CITY OF COCONUT CREEK

DEVELOPMENT REVIEW COMMITTEE (DRC) REVIEW #1

PROJECT NAME:		Lyons Community Center Site	
PROJECT NUMBER:		18030005	
LOCATION:			
APPLICANT/AGENT:		Debra Hernandez, RLA, IBI Group	
REVIEW/APPLICATION		Site	
DISCIPLINE	REVIEWER	EMAIL	TELEPHONE
DRC Chair	Liz Aguiar – Principal Planner	laguiar@coconutcreek.net	(954) 973-6756
Planning	Linda Whitman – Senior Planner	lwhitman@coconutcreek.net	(954) 973-6756
Planning	Natacha Josiah – Planner	NJosiah@coconutcreek.net	(954) 973-6756
Building	Sean Flanagan - Chief Structural Inspector	sflanagan@coconutcreek.net	(954) 973-6750
Engineering	Eileen Cabrera - Engineer II	ecabrera@coconutcreek.net	(954) 973-6786
Fire	Jeff Gary – Fire Marshal	igary@coconutcreek.net	(954) 973-1563
Landscape	Scott Peavler - Landscape (consultant)	speavler@craventhompson.com	(954) 739-6400
Police	Brandi Delvecchio - Police Department	bdelvecchio@coconutcreek.net	(954) 956-6721

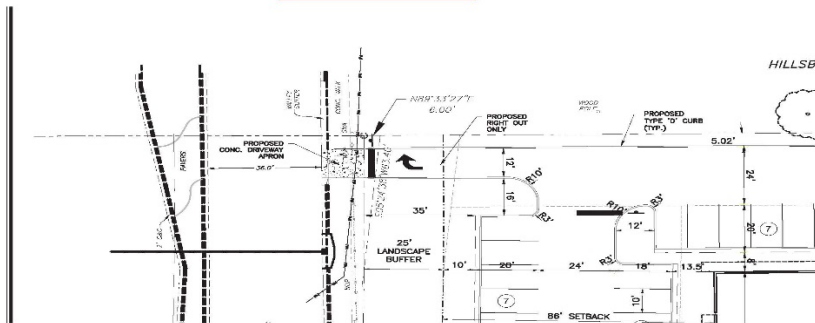
7. Provide 25 LF double yellow pavement markings for all stop signs/ stop bar locations.

Response: As shown on Sheet 6.0, the south entry/exit driveway connection provides a note to install 25 lf double yellow, stop sign and stop bar. The northwest driveway connection is an exit-only drive and provides for a stop sign, stop bar, right-turn only and do not enter sign.
